Access Compliance Report

Public Rights-of-Way

(Curb Ramps)

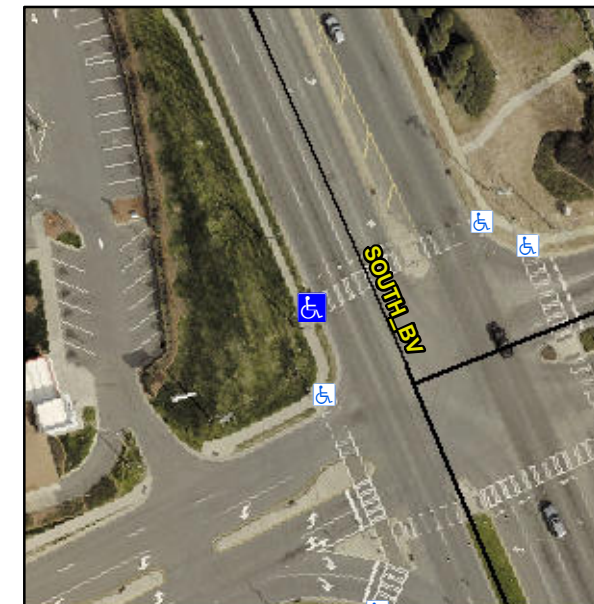
Not Found, R304.2.2

Compliance	Description	Data	Compliance	Description	Data
N/A	Ramp Length (in)	47.0	No	Ramp Slope (%)	13.9
Yes	Ramp Width (in)	48.0	Yes	Ramp XSlope (%)	0.6
N/A	Flare Type LT	N/A	N/A	Flare Type RT	N/A
N/A	Flare Slope LT (%)	N/A	N/A	Flare Slope RT (%)	N/A
N/A	Flare Traversable LT?	N/A	N/A	Flare Traversable RT?	N/A
N/A	Landing Length (in)	N/A	N/A	DWS Provided?	N/A
N/A	Landing Width (in)	N/A	N/A	DWS Contrast?	N/A
N/A	Landing Slope (%)	N/A	N/A	DWS Length (in)	N/A
N/A	Landing X Slope (%)	N/A	N/A	DWS Full Width?	N/A
N/A	Landing Curb? (Y/N)	N/A	N/A	DWS Offset (in)	N/A
N/A	Shared Landing?	N/A			
N/A	Gutter Ponding?	N/A	N/A	Gutter Slope (%)	N/A
N/A	Gutter Lip Ht (in)	N/A	N/A	Gutter X Slope (%)	N/A
N/A	Painted X Walk1?	Yes	N/A	Painted X Walk2?	N/A
	X Walk 1 Direction	To E		X Walk 2 Direction	N/A
N/A	X Walk 1 Width (in)	112.0	N/A	X Walk 2 Width (in)	N/A
	X Walk 1 Slope (%)	2.3		X Walk 2 Slope (%)	N/A
	X Walk 1 X Slope (%)	0.3		X Walk 2 X Slope (%)	N/A

Remove & Replace Entire Ramp.
